UNITED STATES
NUCLEAR REGULATORY COMMISSION
WASHINGTON, D.C. 20555-0001

SAFETY EVALUATION BY THE OFFICE OF NUCLEAR REACTOR REGULATION
RELATED TO AMENDMENT NO. 94 TO FACILITY OPERATING LICENSE NO. NPF-51
ARIZONA PUBLIC SERVICE COMPANY, ET AL.
PALO VERDE NUCLEAR GENERATING STATION, UNIT NO. 2
DOCKET NO. STN 50-529

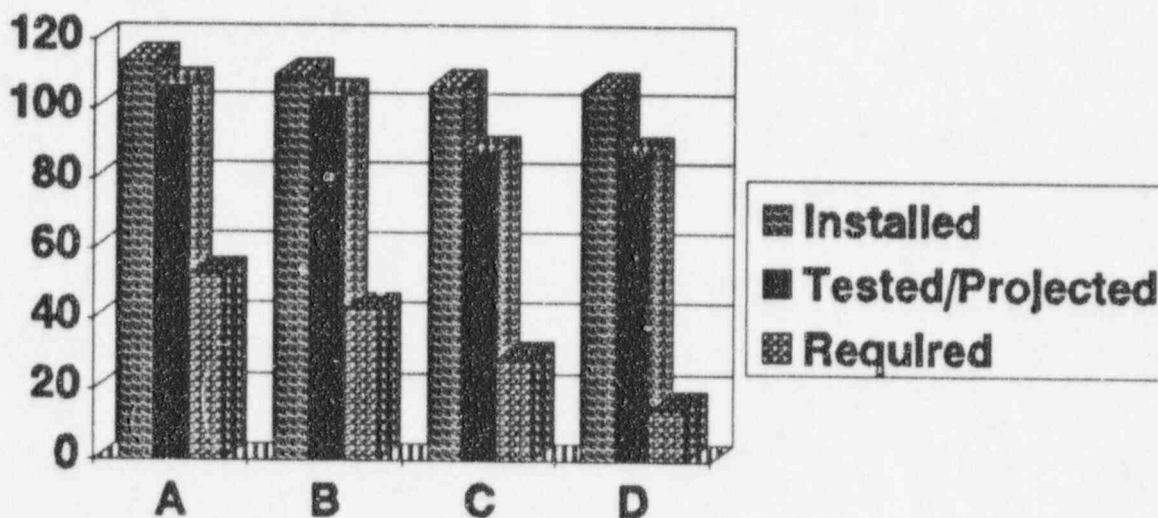
Although battery capacity is less than required by TS 4.8.2.1.e, sufficient capacity remains for the batteries to perform their intended function. The following graph demonstrates the margin in capacity based on projected capacity and actual capacities.

In the most limiting case, the C battery still has greater than 50 percent margin between the projected and required capacities. Therefore, the proposed change to battery capacity requirements does not involve a significant reduction in a margin of safety.
